# ASSESSMENT OF DAM SAFETY OF COAL COMBUSTION SURFACE IMPOUNDMENTS – FINAL REPORT

**City of Columbia, Water  
& Light Department**

**Columbia Municipal  
Power Plant  
Columbia, Missouri**

December, 2013  
Revised April, 2014

Surveyed: JEP	Scale: 1" = 20'	Date: MARCH 2012	Job: 11923	Sheet: 4 of 9
Drawn: BR				
Checked: FEC

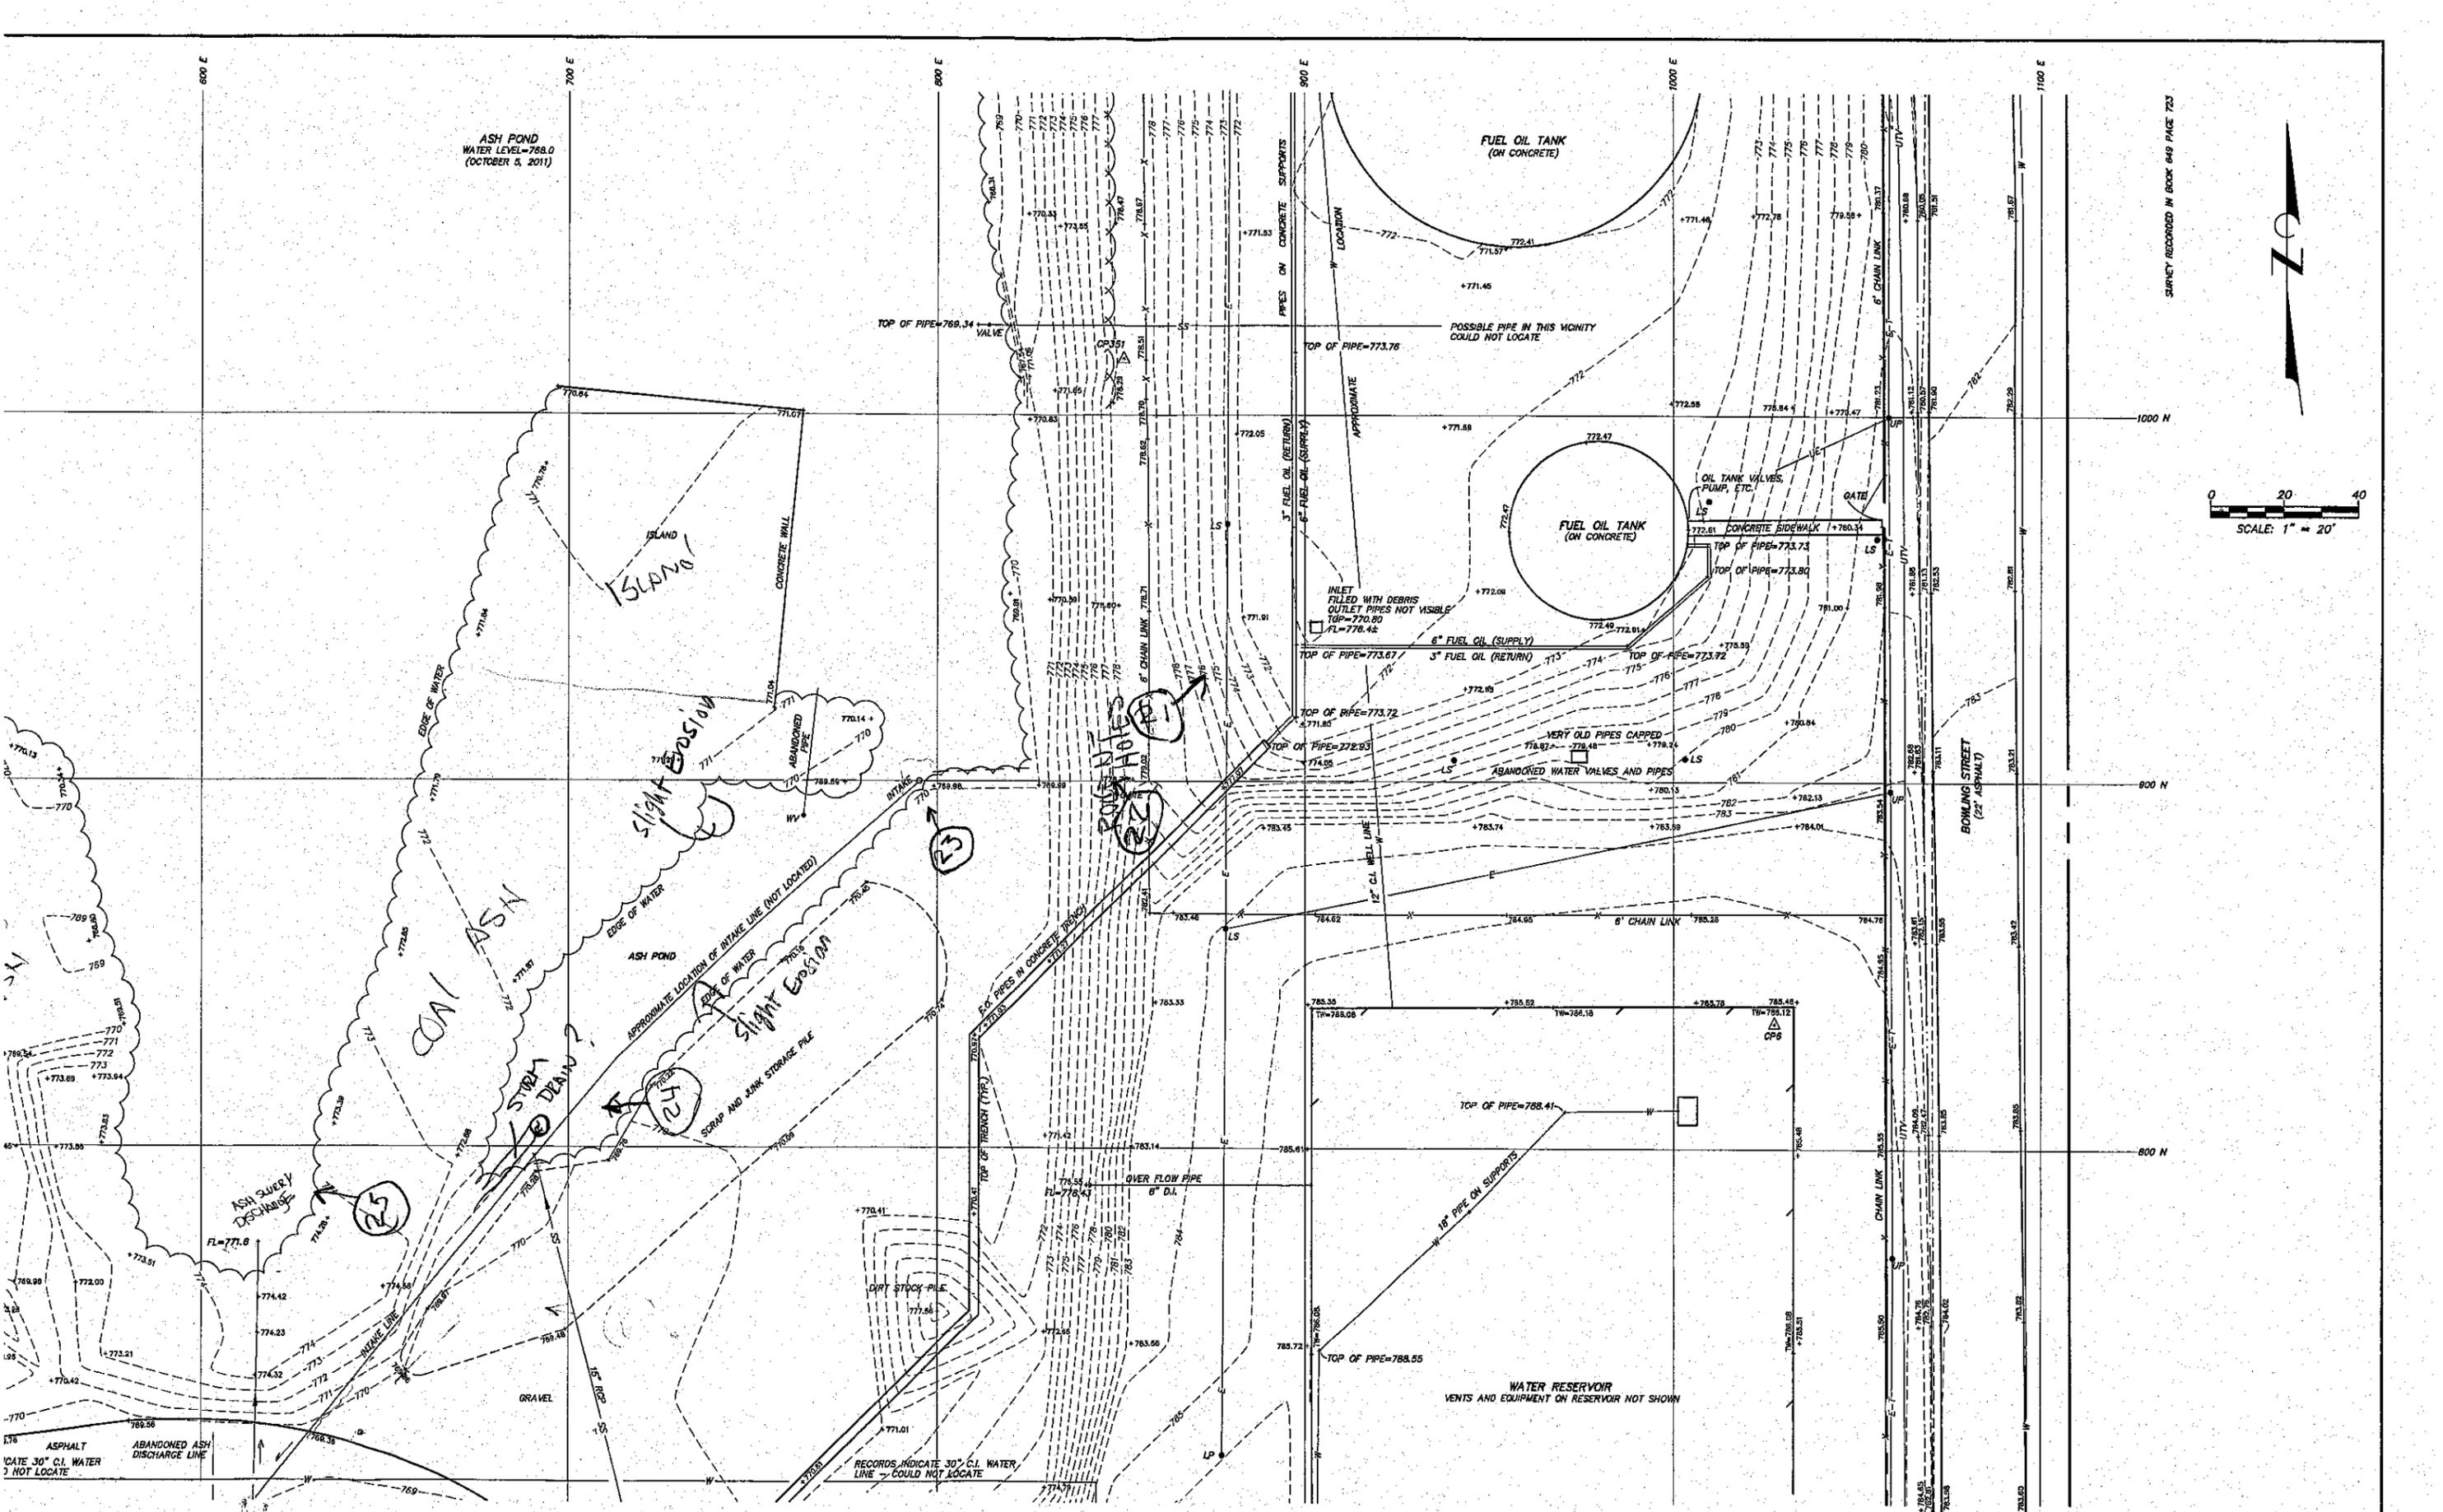
<sup>1</sup>Based on Engineering Surveys & Services Drawing, “Topographic Survey Sheet 4 of 9”, dated March 2012.

The exterior slopes of the CCW impoundment's perimeter embankments were approximately 4H:1V and the interior slopes were approximately 3H:1V, with crest widths ranging from 20 feet for the west and north embankments, to 10 feet wide for the east embankment. The crest of the south embankment is not clearly defined because it is continuous with the adjacent plant grades to the south. The height of the west embankment, considered the "dam" (downstream containment) portion of the impoundment, is listed as 30 feet on MDNR's website. A topographic survey performed by Engineering Surveys and Services (ESS) in March 2012 established the approximate height of the dam at approximately 15 feet.

CDM Smith Action – The height of the dam has been revised to 15 feet throughout the report, based on a topographic survey performed by Engineering Surveys and Services (ESS) in March 2012. ESS drawing Sheet 4 of 9, dated March 2012, shows the embankment crest at El. 770.0 (NAVD88) and the downstream toe at El. 755.

Photograph 5.5. Animal Burrow on North Embankment

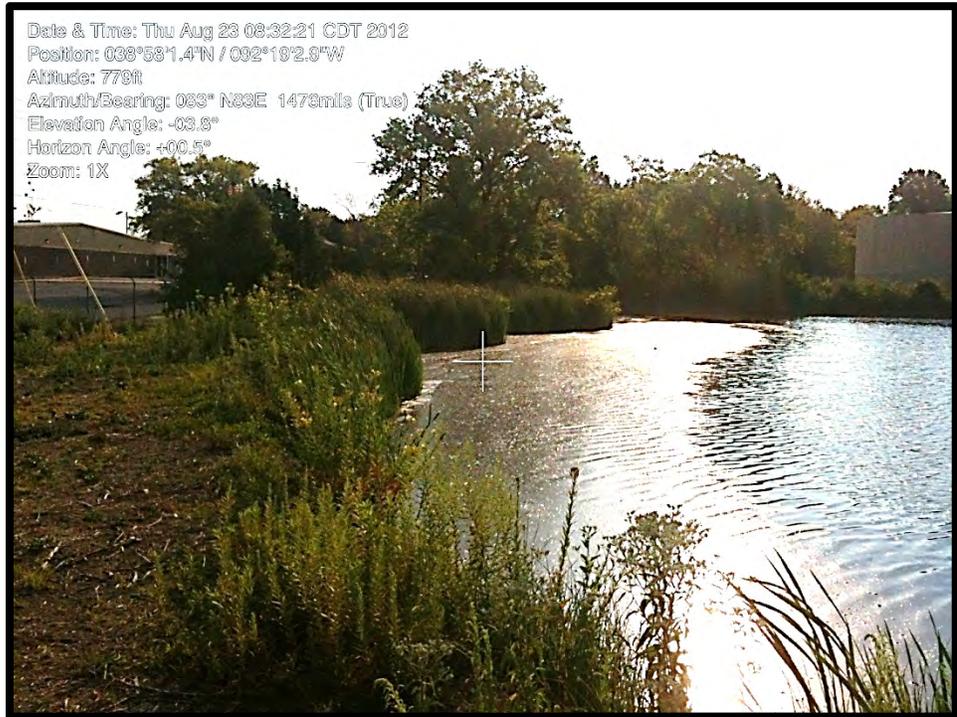
The north and west embankment crest of the CCW impoundment appeared to be in fair condition (**See Photograph 5.1**), and the crest of the east embankment was in good condition (**See Photograph 5.2**). The widths of the west and north embankment crests are approximately 20 feet wide, and the crest of the eastern embankment is about 10 feet wide. The crest of the south and west embankment are partially covered by a gravel drive from the plant to the toe area of the west embankment (**See Photograph 5.3**). Grades along the south impoundment perimeter generally match the grades of the adjacent plant, so no clearly defined crest is apparent.
